Extreme Engineering 9198-B Ridge Road Newcastle CA, 95658 USA Phone: 916/663-1560 Fax: 916/663-9249 info@extremeengineering.com	Bulletin No:001
		Release Date:04/28/04
		Effective Date:04/28/04
		Supercedes: N/A
		Completion Date:
		Page: 1 of 2
<h1>SERVICE BULLETIN</h1>		
Ride Manufacture: Extreme Engineering	Affected Production Date: All AB-34 and AB-44	
Ride Name: AB-34 and AB-44 auto belays.	Affected Serial Nos.: All	
Model Number: AB-34, AB-44		
<p>Abstract Of Issue: Systems must have the proper amounts of fluid to operate safely. To prevent any issues the following bulletin is being sent. The following details must be checked. Any questions, please refer to on-line manuals @ www.extremeengineering.com or contact us at (916) 663-1560.</p> <ul style="list-style-type: none"> • Fluid level of tank • Loose and or missing parts • Cable installation • Cable condition • Recommended mounting methods of belay in the box.

Fig. A1.2 Service Bulletin

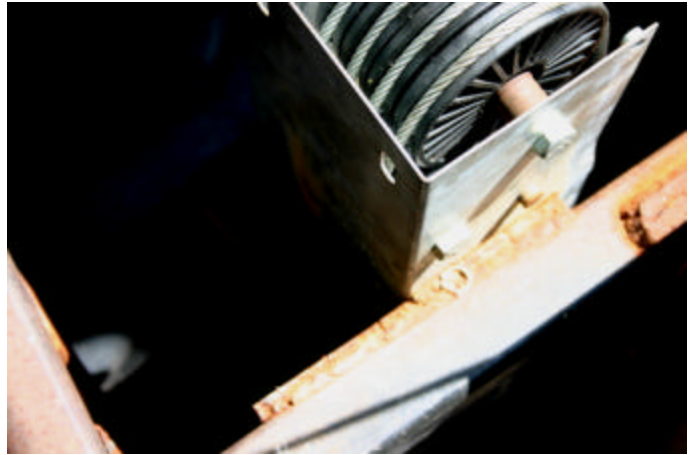
<p>Detail of Issue: Debris/oil on floor, Missing/loose parts, welded not bolted as required, cable installed backwards.</p>

<p>Reason For Release: To ensure that products in service are safe to operate.</p>		
<p>Action To Be Taken: Check fluid levels in all auto belay tanks. All models AB-34 (eight foot long box) must have a minimum of 4 quarts maximum of 6 quarts of Dextron 3/Mercon ATF. Models AB-44 must have minimum of 6 quarts and maximum of 8 quarts. If ever-in doubt of fluid levels, system must be drained and refilled with correct amount of Dextron 3/Mercon ATF fluid. To check proper tank level; Allow cable to fully retract to top of wall. (Attach rope for retrieval) Site-glass type tank, look into site glass with bright flashlight if reddish fluid is visible system level is correct. Non-site glass type, Release all air pressure from tank by removing air valve with removal tool. NEVER remove any fitting or hose from system without first releasing all system pressure. Remove gauge from tank top using a 14mm wrench. Using a clean wire (32" long) as a dip stick insert to tank bottom. For proper level 3" to 6" of fluid must be present. Seal and install gauge. System Pressures; AB-34 55 PSI to 65 PSI AB-44 75 PSI to 85 PSI Or as marked/tagged on specific system. All fasteners, snap-rings, clips, lids, caps, hoses must be properly installed and operational. No loose parts/pieces allowed. Any oil or leaks must be investigated and stopped before product can be used. Before pressure is added to system correct oil level must be confirmed. All Auto Belay of this model must adhere to mounting specifications out-lined in manual, DO NOT WELD on housing! Cabels must be in excellent condition and installed correctly.</p>
